File Number
 PDC05-099

Application Type
 Planned Development Rezoning

STAFF REPORT

Conceptual Landscape Site Plan (Block F is planned for a potential park site)

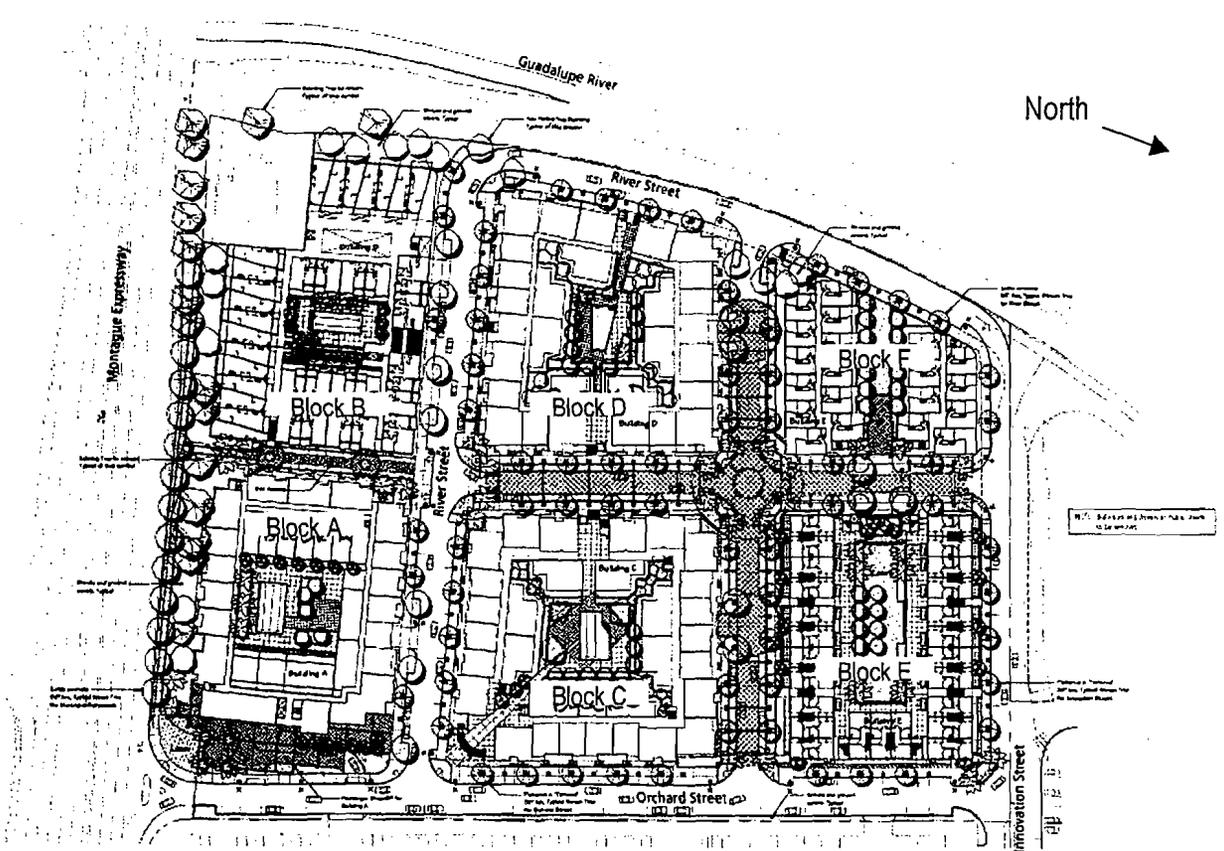
Although not depicted on the conceptual landscape plan above, the applicant is proposing to dedicate Block F (approximately 1 acre) to the City for a public park. The project also includes dedication of approximately 2.45 acres for new public streets. Because the project is located within the Rincon de Los Esteros Redevelopment area, 20% of the units will be designated as "affordable" per City Policy.

Additionally, Planning Department staff is requesting that the project proponent provide pedestrian access to the existing Guadalupe River trail from somewhere along the edge of the subject property. Early submittals of site plans from the project applicant, as well as current submittals for the Planned Development permit, show an access point to the existing trail from the eastern edge of Block F. Staff is looking to pursue access to the creek as a part of future development of the subject site.

Block F, including the proposed public streets fronting Block F on the west and north sides, would be dedicated to the City, and be at least one acre in area. A fully developed pedestrian access path would be required to be dedicated to the City as part of a development standard for the proposed Planned Development Zoning District, to access the existing Guadalupe River trail from a point along the edge of the subject property.
